July 10, 2020

**Subject: DEP File No. 137-1534  
Additional Information for Proposed Seasonal Floating Dock  
767 Monument Street, Concord, Massachusetts  
Fenn School - Applicant**

FENN SCHOOL DOCK  
676 MONUMENT STREET  
CONCORD, MA

**2 SITE PREPARATION, EROSION CONTROL AND DETAIL PLAN**

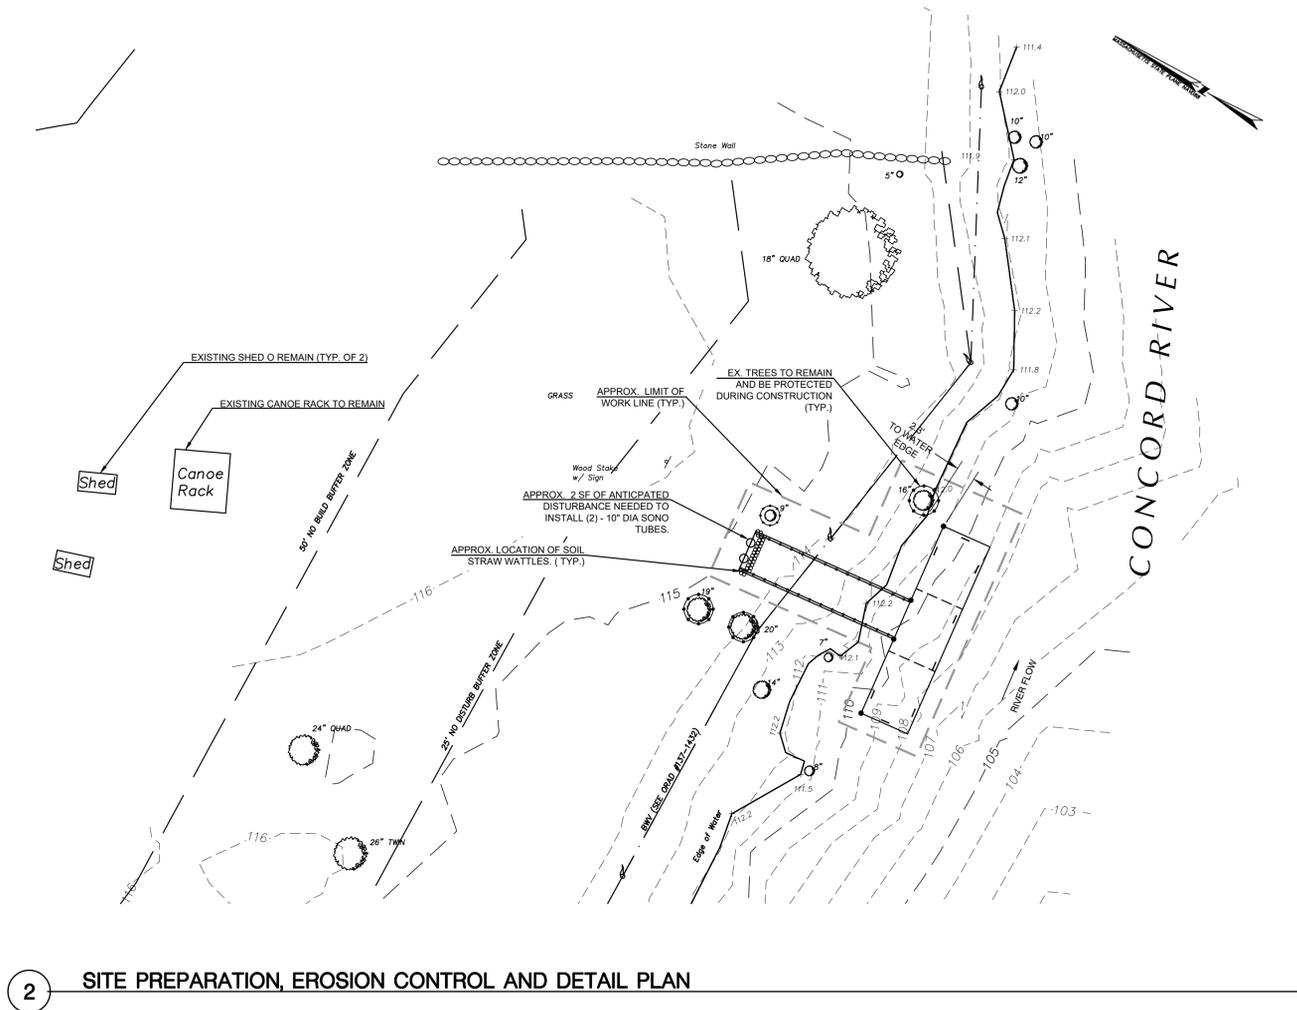
*Please clarify if the canoe rack is a permanent structure, and show its location on the plans.*

*Demarcate on the plans the 25-foot NDZ, the 50-foot NBZ and the 100-foot buffer zone.*

*Show or note the off-season storage area of the seasonal dock sections and canoes.*

The canoe rack is not a permanent structure and not attached to the ground. The existing rack is depicted on the revised NOI plans. The existing temporary rack and storage lockers are located outside of the 50-Foot No-Build Zone ("50-foot NBZ"). The future racks also will be located in this same area, outside of the 50-foot NBZ during the boating season, as well as the off-season. The storage lockers are removed from the canoe launch area during the off-season, while the canoes racks remain in the launch area during the off-season.

The 25-foot NDZ and 50-foot NBZ are depicted on the revised NOI plans. The 100-foot buffer zone extends beyond the image area of the seasonal dock and gangway plans.

The dock sections, gangway and canoes will be stored outside of the 50-foot NBZ and outside of the 100-year flood plain (regulated as Bordering Land Subject to Flooding). They will be stored in the vicinity of the existing canoe rack which is depicted on the revised project plans.

1 SONO TUBE DETAIL  
SCALE: NTS

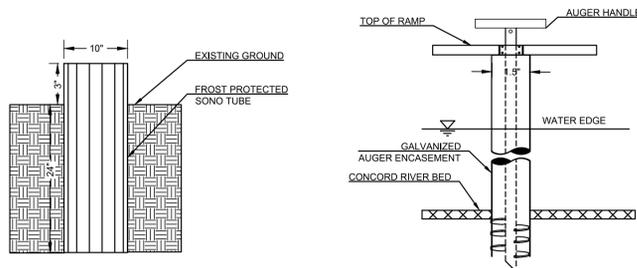
*Provide temporary and permanent impact area for work within the 0-25 No Disturb Zone and the 25-50 foot No Build Zone. Waivers for work in these resource areas also need to be provided (i.e. written responses to each of the criteria).*

The only permanent alteration in the 0-25 foot No Disturb Zone (“NDZ”) is the installation of two 10-inch diameter sono tubes for the gangway footing. Combined these represent less than 1 square foot (0.545 square foot) alteration. The gangway will be installed seasonally, and as depicted on the revised NOI plans, it is elevated above the existing grade to avoid alteration of the land surface regulated as the 25-foot NDZ, buffer zone, BVW and Bank. No structures (temporary or permanent) are proposed in the 25- to 50-foot NBZ.

3 DOCK PROFILE A-A  
SCALE: 1:10 (H)  
1:2 (V)

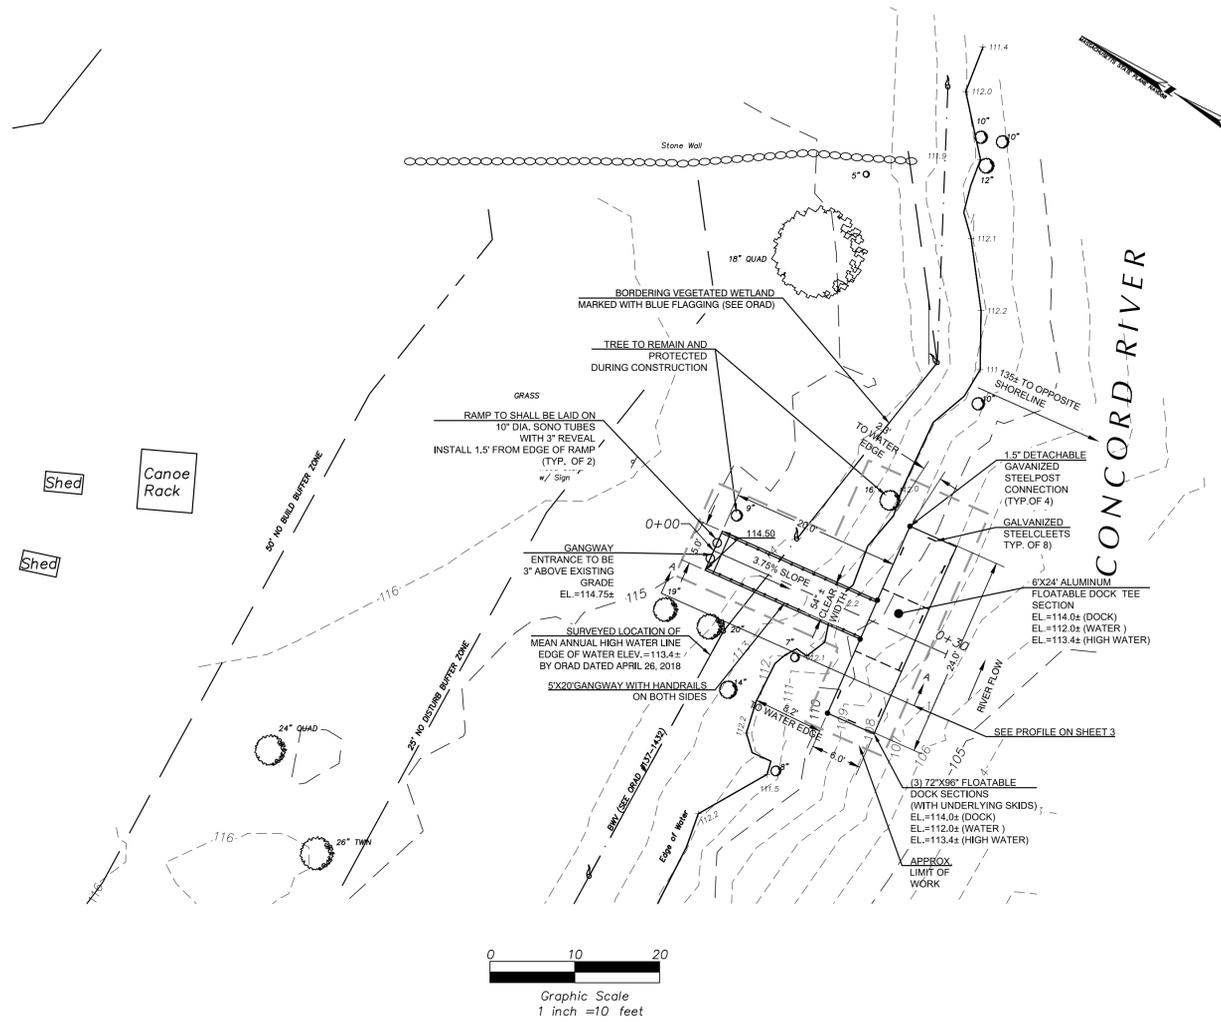
*Wetlands were approved under a 2018 Order of Resource Area Delineation on a plan prepared by Stamski and McNary. The proposed project is shown on a plan prepared by Samiotes Consultants, and it is difficult to understand the project impacts as the resource areas are not clearly shown. For example, the application notes no impact to BVW, but from the Samiotes plan, it appears that a portion of the gangway falls within this resource area. The project plans should be revised to show the approved resource area boundaries in relation to the proposed work so that project impacts are clear.*

The wetland boundaries approved pursuant to the 2018 ORAD were depicted on the original Notice of Intent ("NOI") plan set. The revised plan includes the flag symbol to better identify the previously approved boundaries. The gangway is suspended over the ground surface to avoid altering BVW and Bank. See the revised NOI plan set which include a cross-section through the seasonal dock and gangway to show how this layout avoids altering the ground surface.
